Title of Change:	Improve FAB process variation of SuperFET3 FRFET by optimizing Mask design.
Proposed Changed Material First Ship Date:	26 Oct 2023 or earlier if approved by customer
Current Material Last Order Date:	N/A <i>Orders received after the Current Material Last Order Date expiration are to be considered as orders for new changed material as described in this PCN. Orders for current (unchanged) material after this date will be per mutual agreement and current material inventory availability.</i>
Current Material Last Delivery Date:	N/A <i>The Current Material Last Delivery Date may be subject to change based on build and depletion of the current (unchanged) material inventory</i>
Product Category:	Active components – Discrete components
Contact information:	Contact your local onsemi Sales Office or kyuwon.sim@onsemi.com
PCN Samples Contact:	Contact your local onsemi Sales Office to place sample order. Sample requests are to be submitted no later than 45 days after publication of this change notification. Samples delivery timing will be subject to request date, sample quantity and special customer packing/label requirements.

Final Product/Process Change Notification

Docum

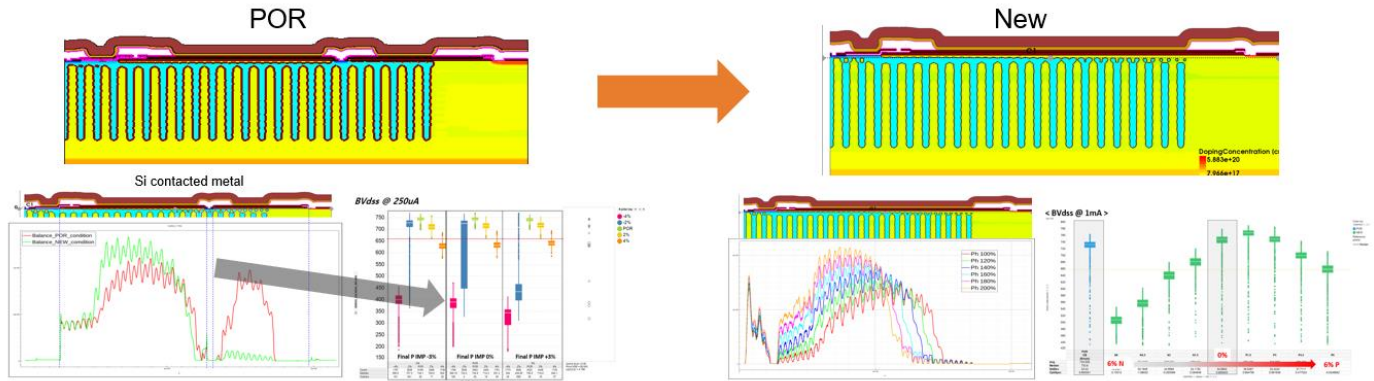
In order to achieve SF3 FRFET BVdss charge balance improvement, onsemi optimized PIL cell pitch and removed Si CNT ring in order to make stable charge balance margin and higher BV typical value.
Please refer below illustration.

1. Ring design change: Si contact removed (No Si CNT ring)
2. MOCVD applied
3. Pillar Cell Size Reducing from 0.06 to 0.02 (PIL2 0.02 step)

POR	NEW
1. Pillar2 circular step	0.06step POR (0.06um) : Ring diameter decreases 0.06um per 2 circular rings. 2.54um, 2.60um, 2.66um, 1.9um	0.02step NEW (0.02um) : Ring diameter decreases 0.02um per 2 circular rings. 2.18um, 2.20um, 2.22um, 1.9um
2. Ring design	Si Contacted	No Si Contacted
3. Barrier metal	Ti 200A + TiN 1600A	IMP Ti 300A / MOCVD 200A + PVD TiN 1200A
